SUBJECT: STAFF ASSESSMENT OF DUKE'S RESPONSE TO CONFIRMATORY ACTION  
LETTER REGARDING DUKE'S COMMITMENTS TO ADDRESS EXTERNAL  
FLOODING CONCERNS AT THE OCONEE NUCLEAR STATION, UNITS 1, 2,  
AND 3 (ONS) (TAC NOS. ME3065, ME3066, AND ME3067)

SAFETY EVALUATION BY THE OFFICE OF NUCLEAR REACTOR REGULATION

CLOSURE OF INUNDATION SITE RESULTS

OCONEE NUCLEAR STATION, UNITS 1, 2, AND 3 (ONS)

Figure 1: Jocassee Dam Breach Dimensions

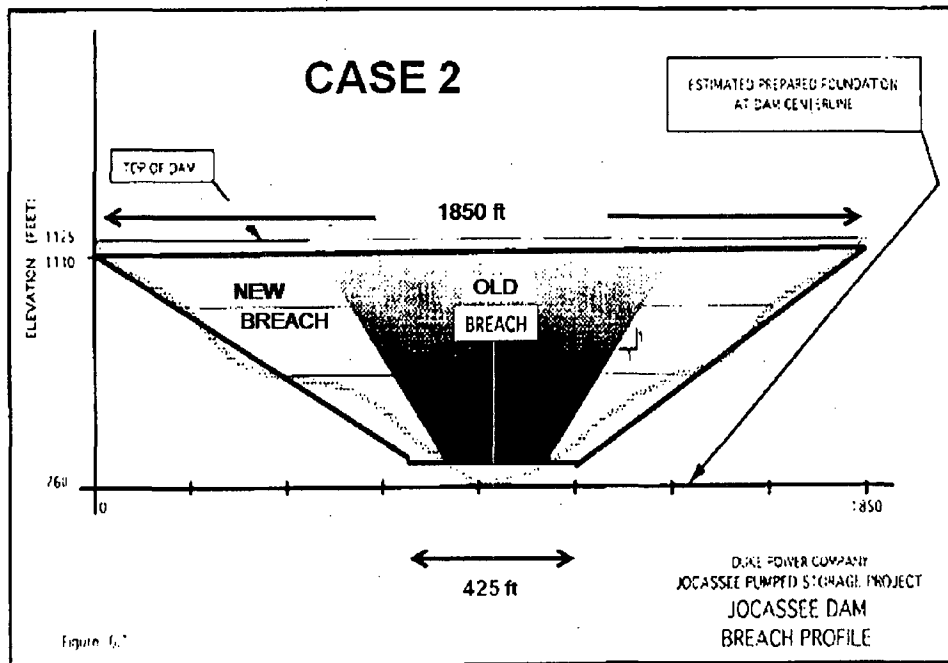
The staff determined that the Jocassee Dam starting reservoir level of 1110 ft., as described above, is conservative.

The Jocassee Dam overall breach dimension assumes the entire loss of the dam embankment and massive erosion of bedrock at the dam base. The biotite gneiss which comprises the bedrock type at the base of the dam would be extremely resistant to erosion, so a large degree of conservatism was added to the breach size. The average width of the assumed dam breach (~1137 ft) is one of the overall breaching parameters. This is larger than the average width estimated using Froehlich's 2008 methods (i.e., ~900 ft).

The Jocassee Dam breach hypothetical failure time of 2.8 hrs. is very short for a dam with the quality of construction, basal rock type, and degree of monitoring of the Jocassee Dam, so the staff determined that adequate conservatism was added to the breach size. The licensee used Froehlich's 2008 methods in their estimation. It is important to note that the breach dimensions and breach times are related.

Figure 2: Satellite image of Jocassee Dam showing submerged quarry site and embayment area below the dam which has a restricted outlet connection to the rest of Keowee Lake

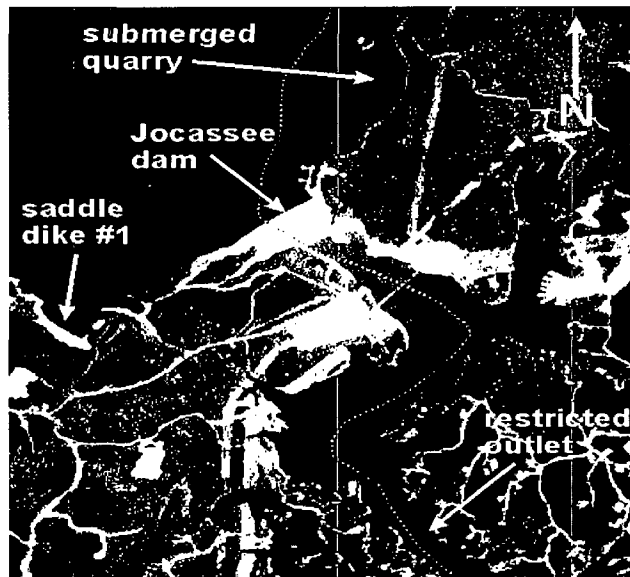
The tailwater effect of the convoluted flood pathway below the Jocassee Dam was not considered. A limit on the depth of hypothetical breach cutting at Jocassee (and, therefore, on the peak discharge) is provided by the tailwater elevation of 800 ft, which represents the Keowee normal pool level. This is the base elevation that was assumed for the hypothetical breach at Jocassee. The staff agreed that it is conservative to not include the tailwater effect of the convoluted flow pathway below the Jocassee Dam, because excluding it would shorten the time required to empty the reservoir.

Figure 4: FLOW MODEL SCHEMATIC (Duke, 2009)

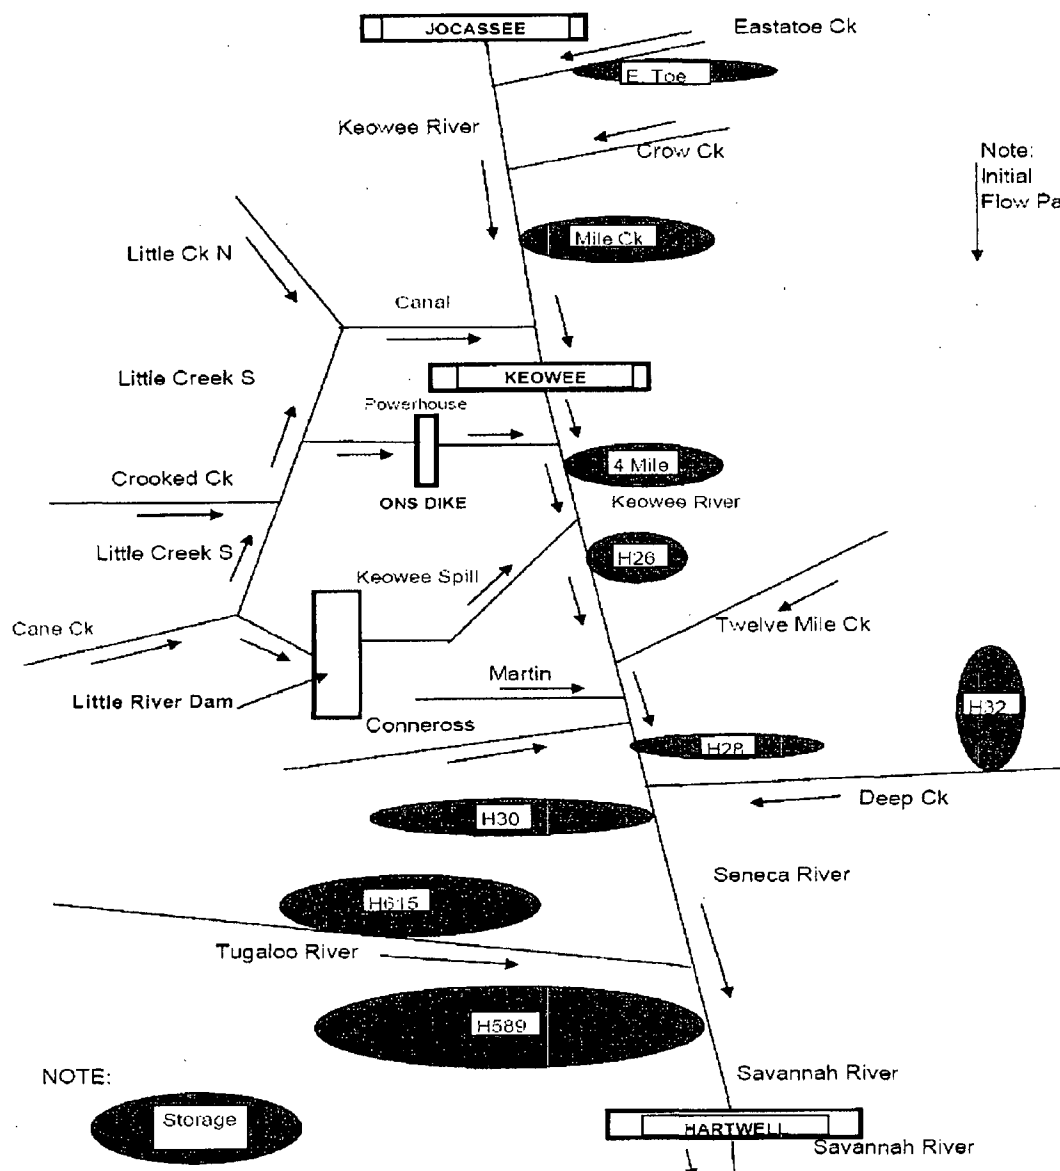
Early in the review, there was a concern about the ability of a one-dimensional (1-D) model to effectively simulate the flow regime immediately upstream of the canal to the north of the plant (connecting the Keowee River Basin to the Little River Basin), where the downstream velocity vector makes a 90-degree change in direction. Also, the potential for inundation of the site comes from many potential sources and is likely to flow in different directions without channelization. Such overland flow may involve eddy patterns, flow recirculation, and spill over barriers. Alternate wetting and drying of area elements may also be required depending on the overland flow patterns. For these reasons, a two-dimensional (2-D) model was coupled with the HEC-RAS simulations at boundaries, sufficiently remote, where the hydraulic parameters of flow and depth would be relatively unaffected by flow over the site.

The 2-D model chosen was developed by the U.S. Department of Interior, Bureau of Reclamation, entitled "Sedimentation and River Hydraulics—Two Dimensional River Flow Modeling (SRH-2D)." For the modeling effort, a 2-D mesh of triangular and quadrilateral elements was constructed of the area surrounding the station. The mesh size was selected to model the desired area, while keeping the computational array to a manageable size. The final computational mesh has approximately 57,500 unstructured elements. The mesh is coarser in areas that are farther away from ONS and finer in areas where more detail is required. The upstream boundary is about 6,200 feet wide and the upstream boundary condition consists of an inflow hydrograph. The downstream boundary conditions consist of stage hydrographs.

Figure 5: TWO-DIMENSIONAL MODEL BOUNDARY DEFINITIONS (Duke, 2010)

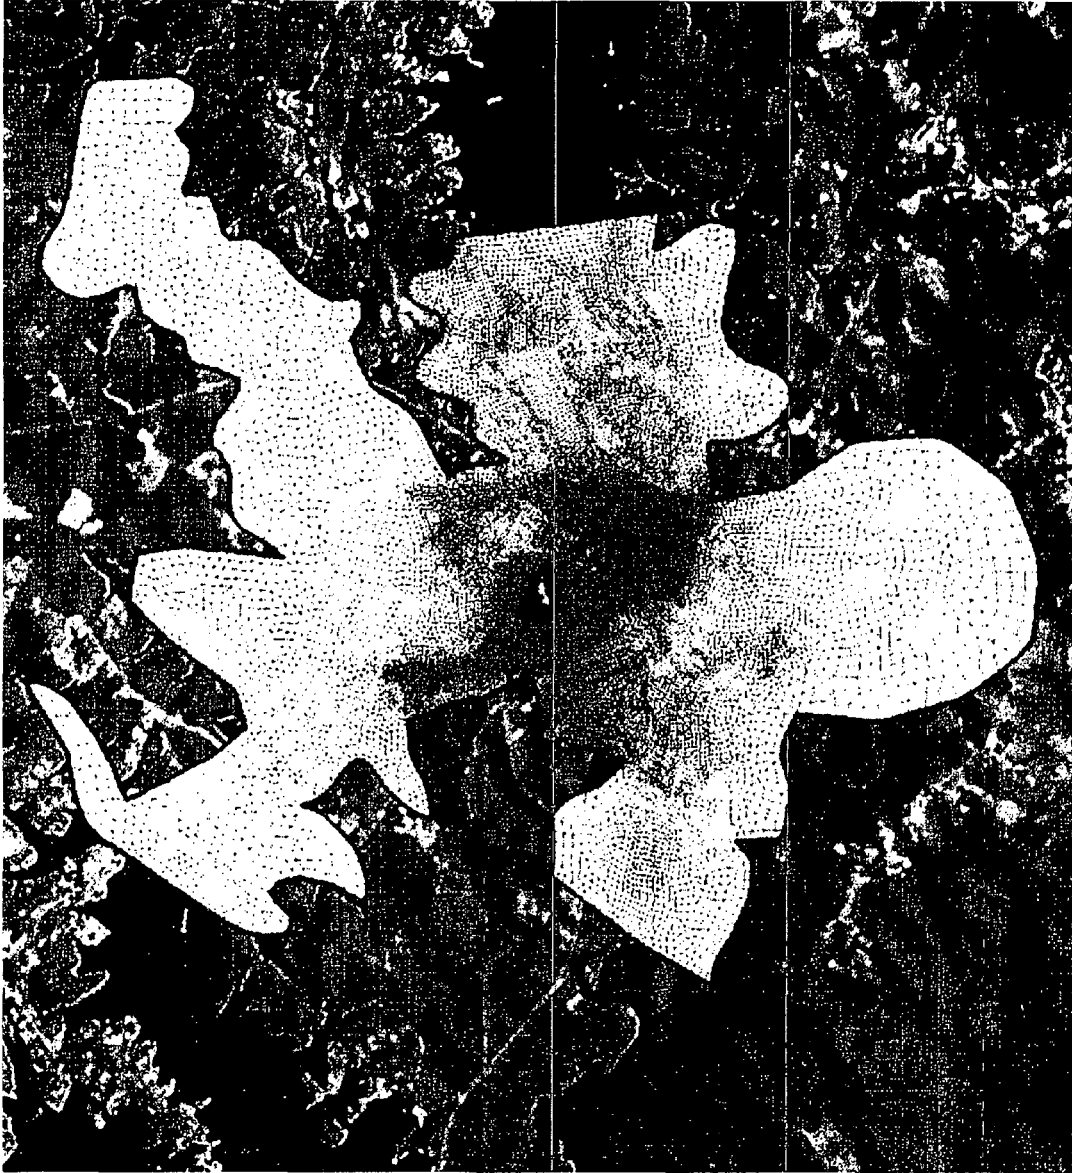
The one-dimensional HEC-RAS and two-dimensional SRH-2D models are not dynamically coupled; and mass and momentum between the two models cannot be conserved. Hence, potential backflow between the inflow and outflow boundaries cannot be incorporated into the model. Also, the simulations represent an extreme and unobserved scenario, and parameters such as roughness coefficients over the site cannot be calibrated, requiring the selection of conservative values. The lack of coupling resulted in higher water levels from the 2-D simulations at the upstream boundaries than from the HEC-RAS runs (Wilson, 2010 and Young, 2009). The
